**RE: CTP Management Property**

RE: Fire Marshal review of CTP MANAGEMENT PROPERTY TP 26-006-101-004

Reference: County Line Road (Toll Brothers, Inc.) – Sketch Plan Review 1 (B5 and B6 Uses)  
TMP #26-006-101, Provco Pinegood Chalfont, LLC  
TMP #26-006-101-003, CTP Management LLC  
TMP #26-006-101-004, CTP Management LLC

**B5 USE CONCEPT PLAN**  
57 3-STORY TOWNHOMES  
**CTP MANAGEMENT PROPERTY**  
NEW BRITAIN TOWNSHIP, BUCKS COUNTY, PA

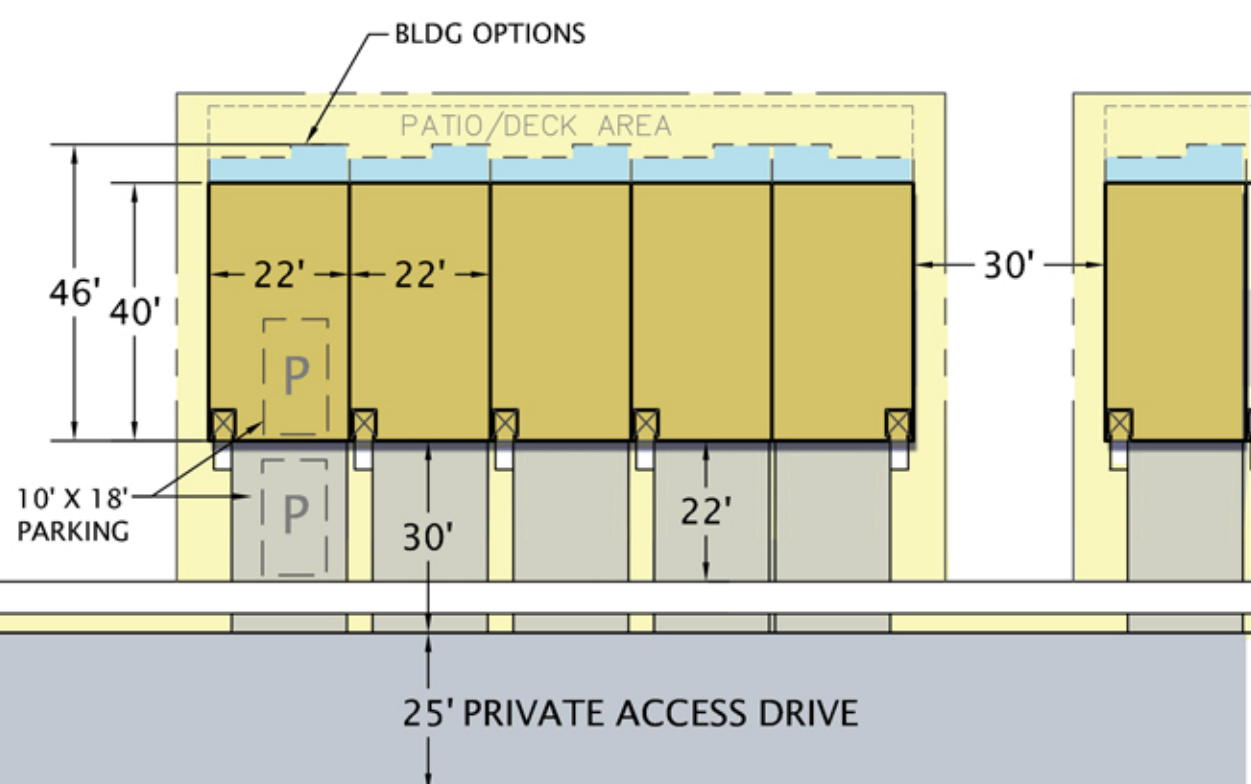
1. Due to the width of the roads there should be No Parking on both sides of road ways
2. Supply two fire hydrants one at the area of road B and C and one at beginning of road A

- a. §27-305.B.B5.b.3 – Facade. For every attached grouping of single-family attached, a minimum of two changes in the front wall plane shall be provided. Such change shall involve a minimum variation or offset of four feet. Though a “B5-Conceptual Three-Story Townhome” rendering was submitted, it does not appear that the grouping of townhomes would comply with this 4-foot offset.

- c. §27-305.B.B5.b.5 – Requires a minimum front yard setback of 30 feet from an ultimate right-of-way of a street, and 20 feet from any off-street parking spaces. The plan does not show an ultimate right-of-way for the proposed roads as a private access drive is proposed. The Subdivision and Land Development Ordinance (SALDO) §22-705.3.D states that private streets shall be designed to the specifications of a minor collector which requires a 60-foot-wide right-of-way. The townhomes are currently located 30 feet from the proposed *cartway*.

18. §27-2901 – The parking requirement for a B5 and B6 use is based on the number of bedrooms per dwelling unit. The plan notes 3-bedroom units and 2 spaces for each unit. We note that the B5 rendering shows 2-car garages, however, the Sketch Plan only shows 1-car garages. The Record Plan shall have a note restricting the number of bedrooms to 3 due to limited parking.

**B6 USE CONCEPT PLAN**  
 64 MULTI-FAMILY DWELLINGS  
**CTP MANAGEMENT PROPERTY**  
 NEW BRITAIN TOWNSHIP, BUCKS COUNTY, PA

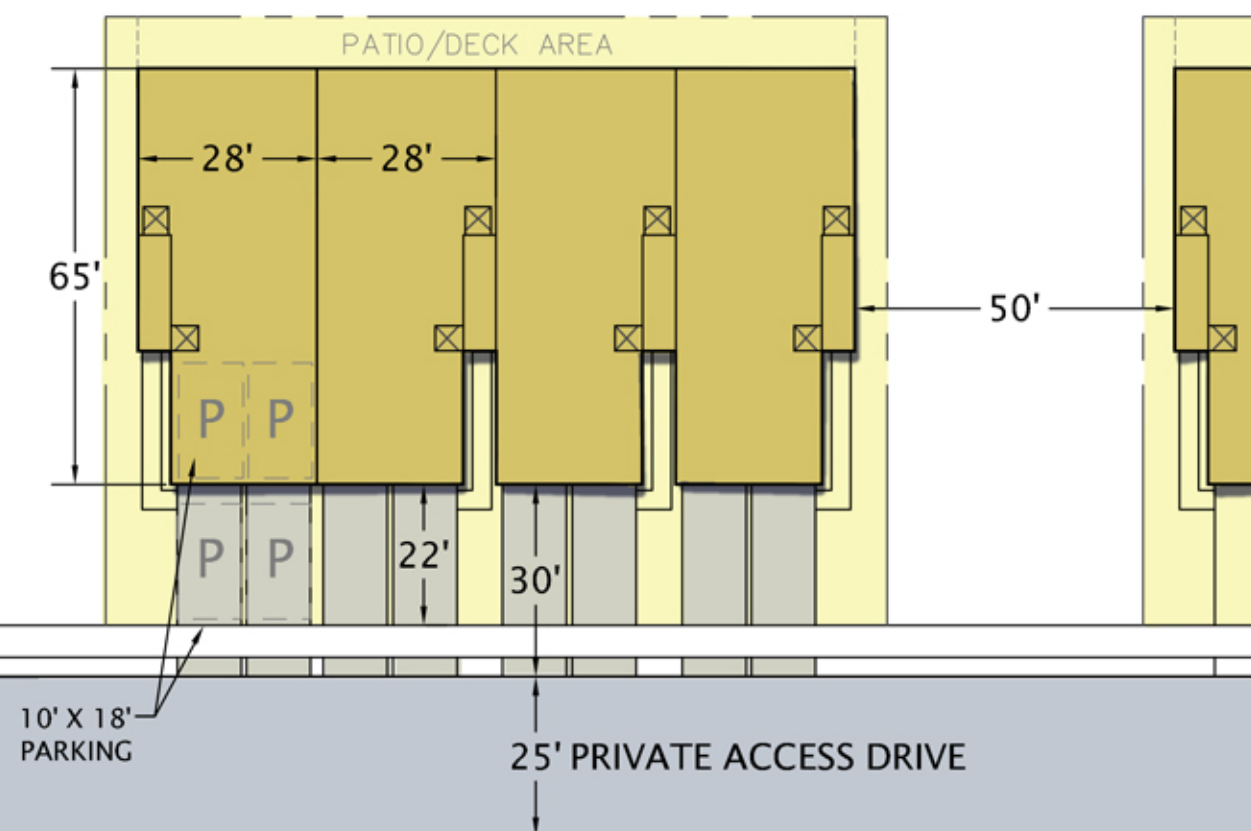
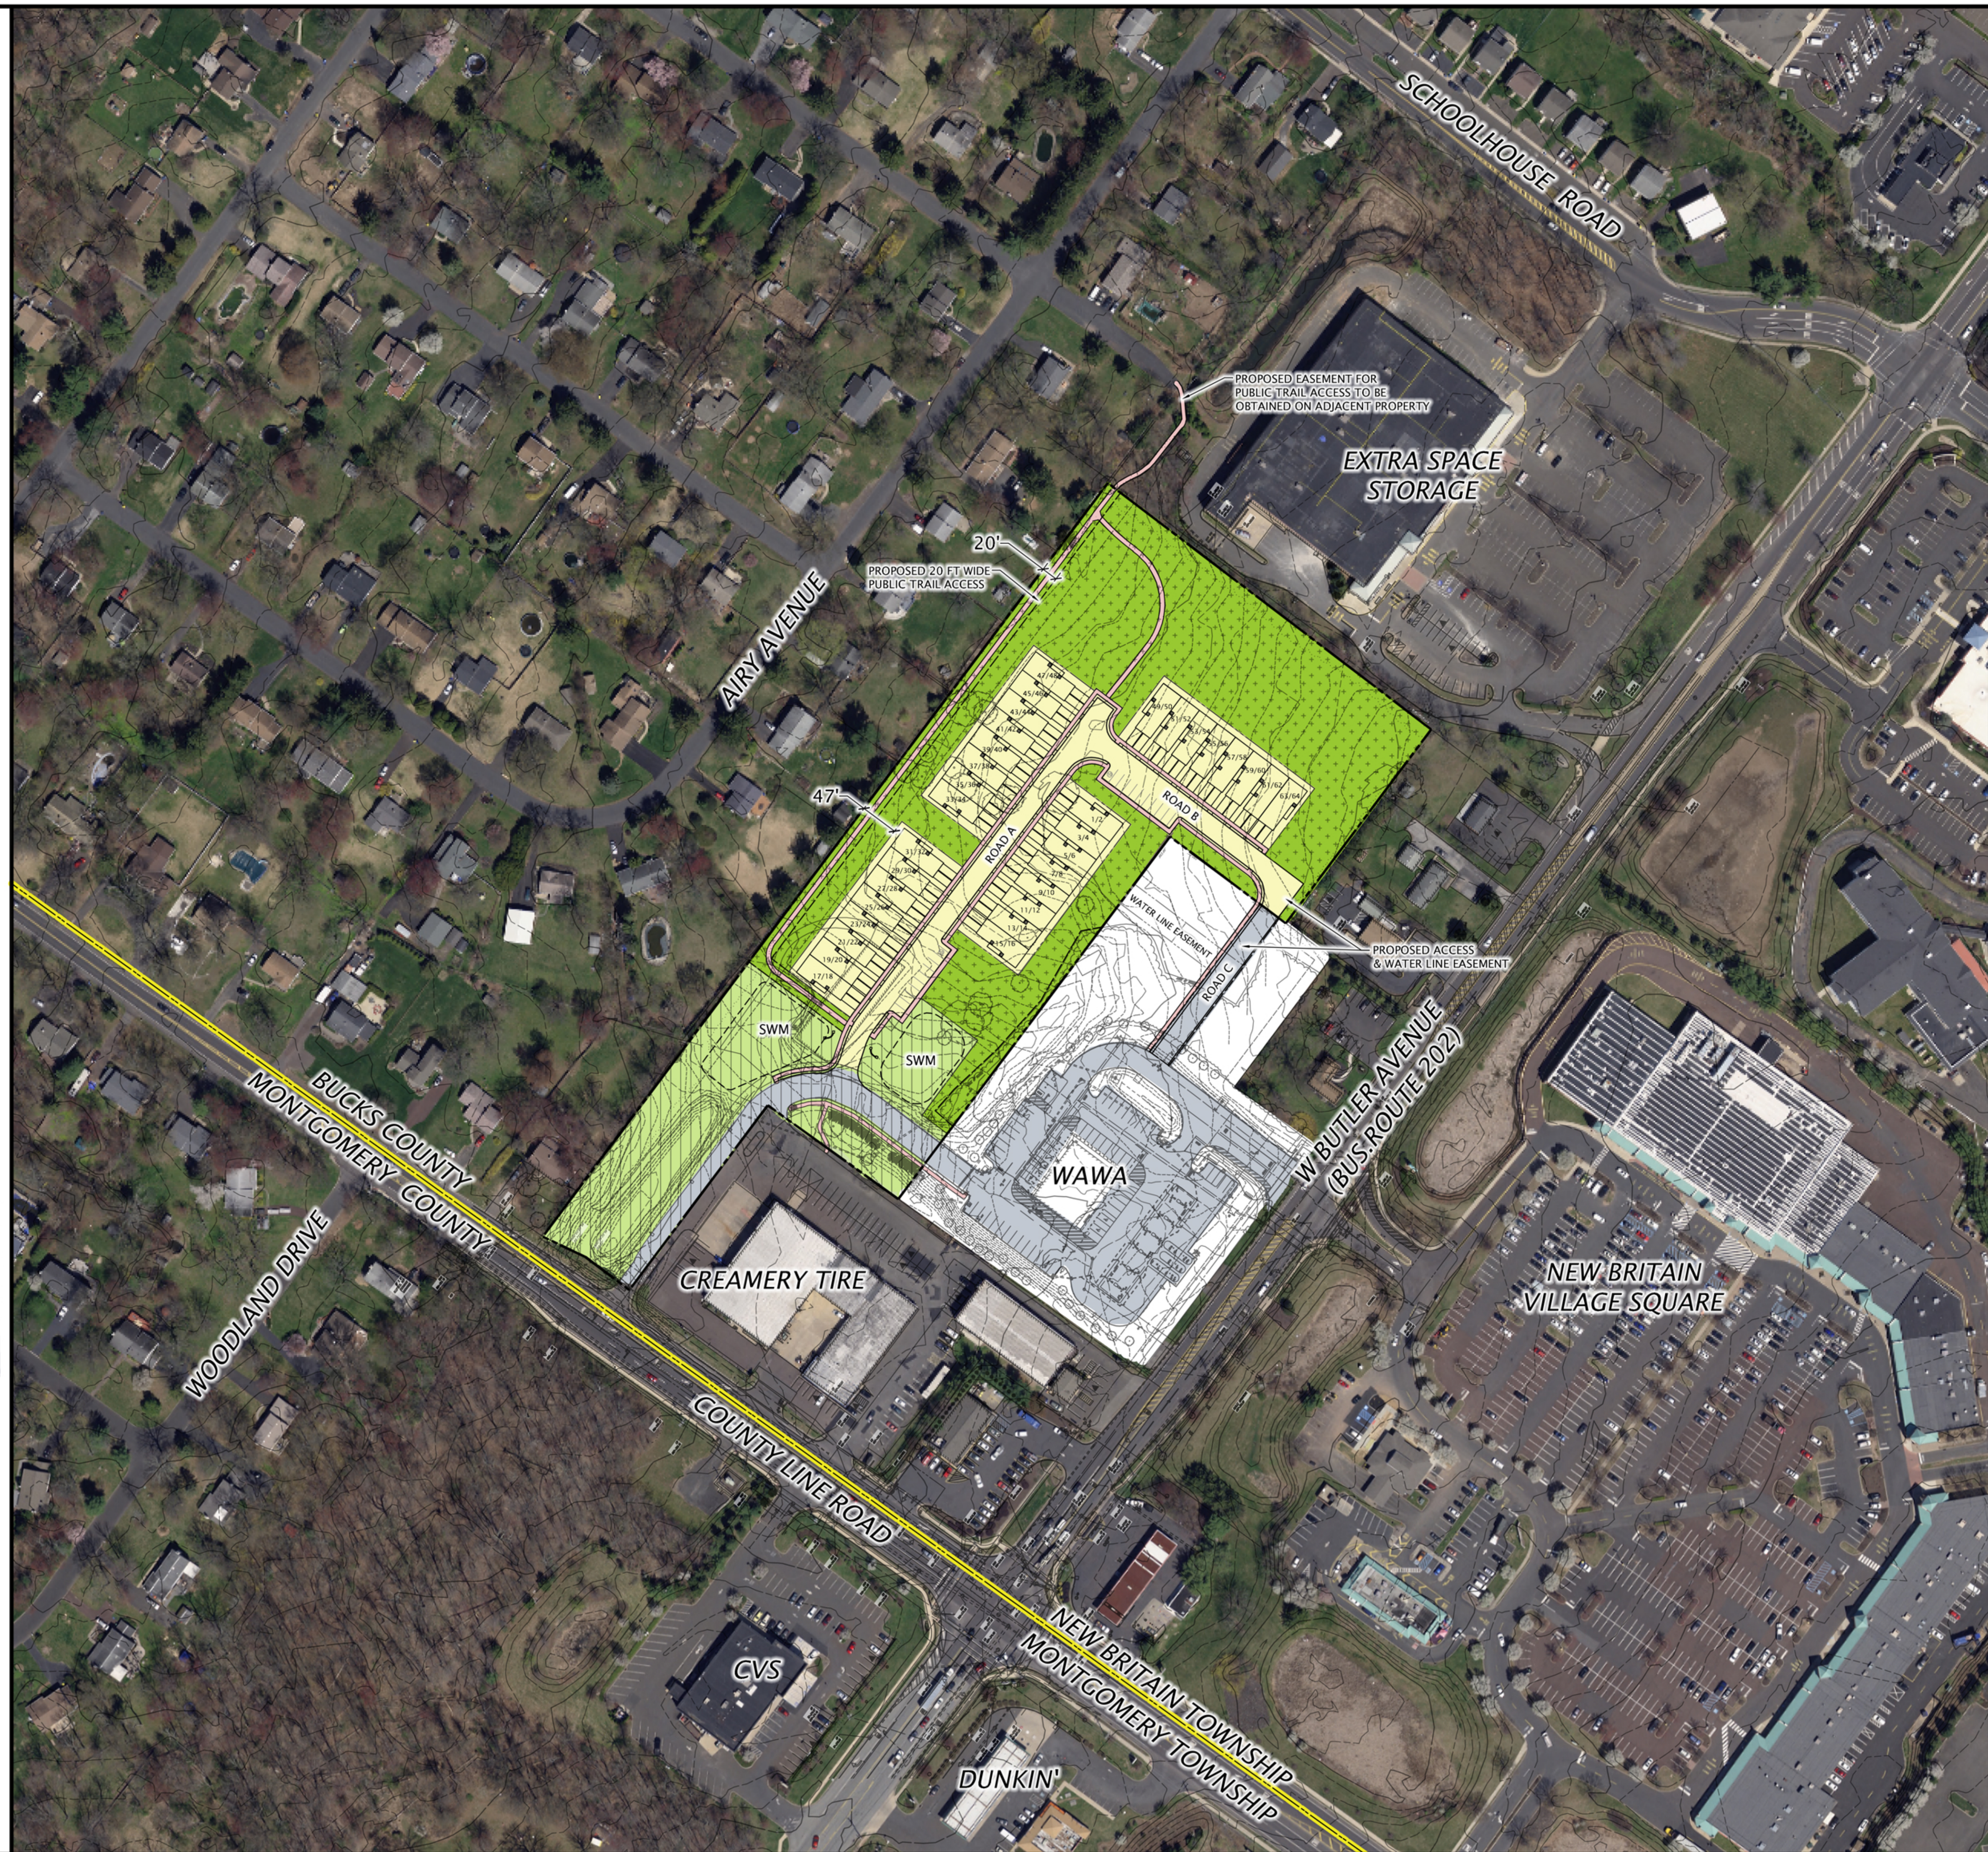
- a. §27-305.B.B6.b.3 – Requires a maximum impervious surface ratio of 30% per lot. The Zoning Requirements table for the B6 sub-use lists a proposed impervious coverage of 30%. An impervious surface breakdown shall be provided on the preliminary plans to verify compliance with this requirement. The plans shall also list the area of impervious considered in the stormwater design.

- b. §27-305.B.B6.b.3 – Requires a building setback of 50 feet from the ultimate right-of-way of a street and 30 feet from any off-street parking spaces. The plan does not show an ultimate right-of-way for the proposed street as a private street is proposed. The SALDO §22-705.3.D states that private streets shall be designed to the specifications of a minor collector which requires a 60-foot-wide right-of-way. The townhomes are currently located 30 feet from the proposed *cartway*. The multi-family dwellings are currently located 30 feet from the proposed *cartway*.

8. §22-705.13.D – Residential driveways shall have a minimum width of 12 feet. The proposed driveways for the B6-Multifamily Use are 10 feet wide.
9. §22-705.13.J – Driveways shall have a minimum turnaround area of 10 feet by 20 feet, or as recommended by the Township Fire Marshal's Office and approved by the Board.

- b. §22-722.4.B. – Building design shall comply with this section of the COD regarding façade, building materials, roof design, colors, building length etc. In addition, the building length for the B6-multifamily uses shall comply with the maximum building length of 150 feet unless the façade is broken by variations with minimum 6-foot offsets and minimum width-to-depth ratio of 4:1. The current buildings measure approximately 225 feet long. It appears that offsets would be required every 100 feet per §22-722.4.B.7.(a).
